Access Compliance Report

Public Rights-of-Way

(Curb Ramps)

Intersection ID: 27962	Main Street: PINE_VALLEY_CLUB_DR	Cross Street: ROYAL_ABERDEEN_CT	Location: SW
ADA ID: 5771C6260C11	Ramp Type: Perp	Initial Pass/Fail: Fail	Overall Compliance: No
Severity Score: 1.25			
Codes/Mitigation Info/Possible Solution		Field Measurements/Component Compliance

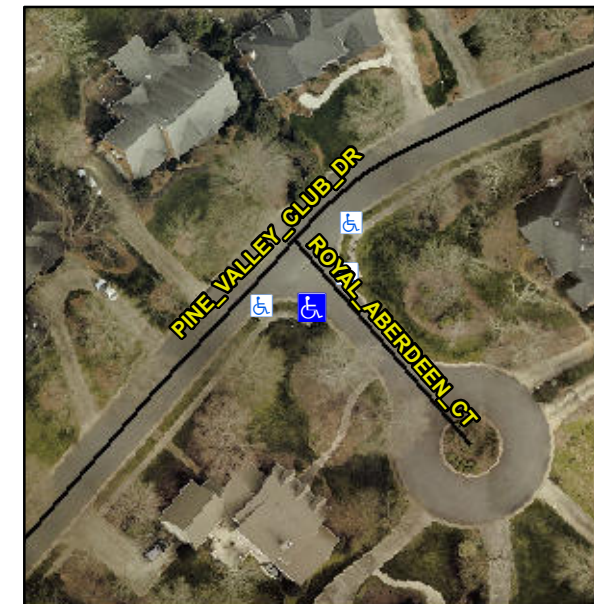
Not Found, R304.5.3

Compliance	Description	Data	Compliance	Description	Data
N/A	Ramp Length (in)	55.0	Yes	Ramp Slope (%)	5.6
Yes	Ramp Width (in)	48.0	No	Ramp XSlope (%)	2.2
N/A	Flare Type LT	N/A	N/A	Flare Type RT	N/A
N/A	Flare Slope LT (%)	N/A	N/A	Flare Slope RT (%)	N/A
N/A	Flare Traversable LT?	N/A	N/A	Flare Traversable RT?	N/A
N/A	Landing Length (in)	N/A	N/A	DWS Provided?	N/A
N/A	Landing Width (in)	N/A	N/A	DWS Contrast?	N/A
N/A	Landing Slope (%)	N/A	N/A	DWS Length (in)	N/A
N/A	Landing X Slope (%)	N/A	N/A	DWS Full Width?	N/A
N/A	Landing Curb? (Y/N)	N/A	N/A	DWS Offset (in)	N/A
N/A	Shared Landing?	N/A			
N/A	Gutter Ponding?	N/A	N/A	Gutter Slope (%)	N/A
N/A	Gutter Lip Ht (in)	N/A	N/A	Gutter X Slope (%)	N/A
N/A	Painted X Walk1?	No	N/A	Painted X Walk2?	N/A
	X Walk 1 Direction	To NE		X Walk 2 Direction	N/A
N/A	X Walk 1 Width (in)	N/A	N/A	X Walk 2 Width (in)	N/A
	X Walk 1 Slope (%)	2.5		X Walk 2 Slope (%)	N/A
	X Walk 1 X Slope (%)	0.7		X Walk 2 X Slope (%)	N/A

Remove & Replace Entire Ramp.
